Comments on Entergy Louisiana's 2015 Integrated Resource Plan

Strengths, Weaknesses, and Implications

Prepared for Sierra Club

April 1, 2015

Figure 1: Recent utility CO₂ forecasts with current and past Entergy forecasts highlighted

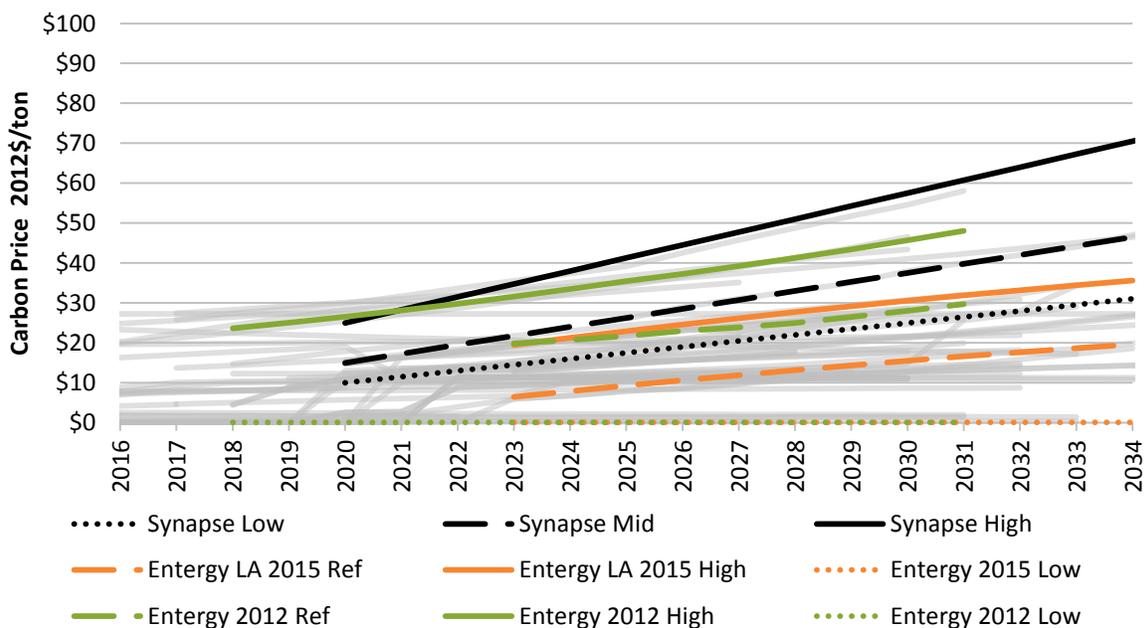
As show in Figure 1, Entergy’s CO₂ price forecasts have decreased over time. The 2015 high case is now as low as the Company’s reference case in 2012. Also shown in Figure 1 are various utilities’ CO₂ price forecasts from across the country. Entergy’s reference case 2015 forecast is far below that of most utilities in most years. Entergy also assumes that the CO₂ price will take effect in 2023. In light of EPA’s proposed Clean Power Plan (due to be finalized in the summer of 2015), Synapse suggests that 2020 is a reasonable timeframe for the start of CO₂ prices for planning purposes.²⁴ Most importantly, however, Entergy should—at the very least—include a non-zero price in its reference case scenario rather than applying its “low” price, which is equal to zero. Several papers discuss the critical and fundamental role of the assessment of CO₂ prices in long-term utility planning.²⁵

The drop in CO₂ price forecasts from Entergy's 2012 IRP compared to the 2015 Draft IRP implies that Entergy now believes the cost of compliance with carbon regulations will be less burdensome than previously forecasted. It is worth noting that, in his comments to the EPA on the draft Clean Power Plan, Chuck Barlow, Vice President of Environmental Strategy & Policy at Entergy, claims that Entergy "must implement additional measures to further reduce CO₂, and these measures likely will have a higher marginal cost than the actions already taken."²⁶ Similarly, in comments the Company filed with the LPSC regarding the potential economic impact of the Clean Power Plan, Entergy admitted that complying with the rule's heat rate improvements at R.S. Nelson alone would cost more than \$60 million.²⁷ The Company's use of a zero carbon price in the reference case scenario is belied by the significant compliance risk identified by the Company in other contexts.

A CO₂ cost greater than zero would favor dispatch of less carbon-intensive resources over coal generation than what the Company's reference case would select, as the analysis currently stands. If the Company fails to properly apply a reasonable CO₂ price forecast, the result will be a carbon-intensive fleet more vulnerable to escalating costs under the Clean Power Plan or any other carbon legislation and/or regulations.
